The Hiawatha Golf Course Master Plan

A Massive Folly!

Compiled By Kathryn Kelly
Member of SaveHiawatha18

March 2023

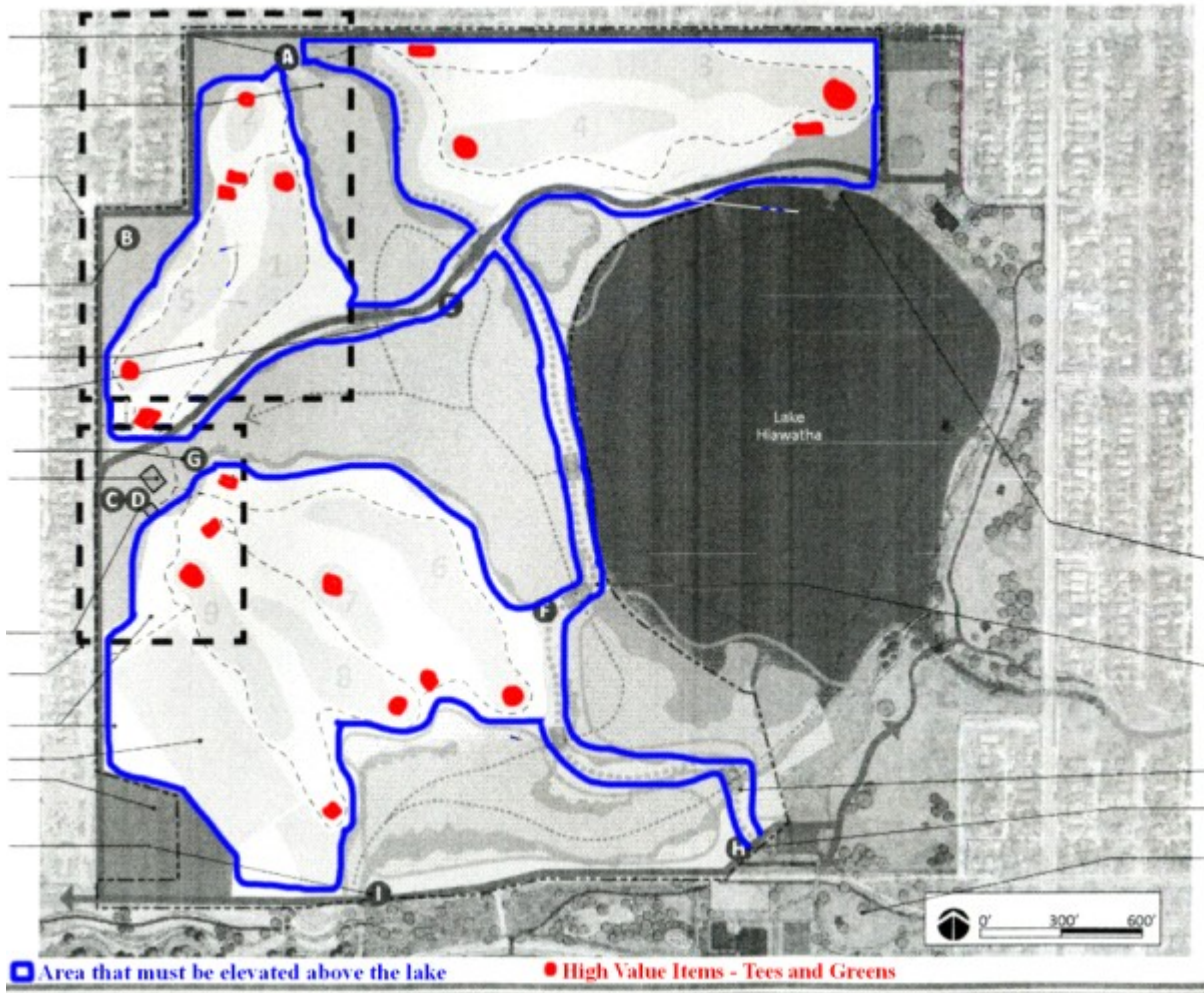
The proposal appears to eliminate or make unsafe two small park areas at E. 44th St. and Longfellow Ave. S. and 19th Ave. S. and E. 43rd St. that are cherished by the neighborhood. This is where the proposed golf course would be built. The park at E. 43rd St. and 19th Ave. S. appears to be part of the proposed 9-hole golf course. It appears the other park at E. 44th St. and Longfellow Ave. S. would be encroached on by the 9-hole plan, likely making it unsafe for use because of flying golf balls. It also appears to bring the golf course closer to the homes, endangering them.

Also, these are the 2 small parks that the MPRB asked to have excluded from the defined

historical site in the Historical Designation just approved by the Minnesota Historical Commission because they are currently outside of the golf course fence line. (5) But, it seems likely that these areas would be absorbed into the proposed 9-hole golf course.

A currently funded project for a bike and pedestrian trail around the golf course also affects these parks, with the trails likely running right through these parks. This trail is supposed to be designed and built in 2023-2024. Will these trails be built and then torn up later? The MPRB has stated that the Hiawatha Golf Course Master Plan may affect the plan for this trail.
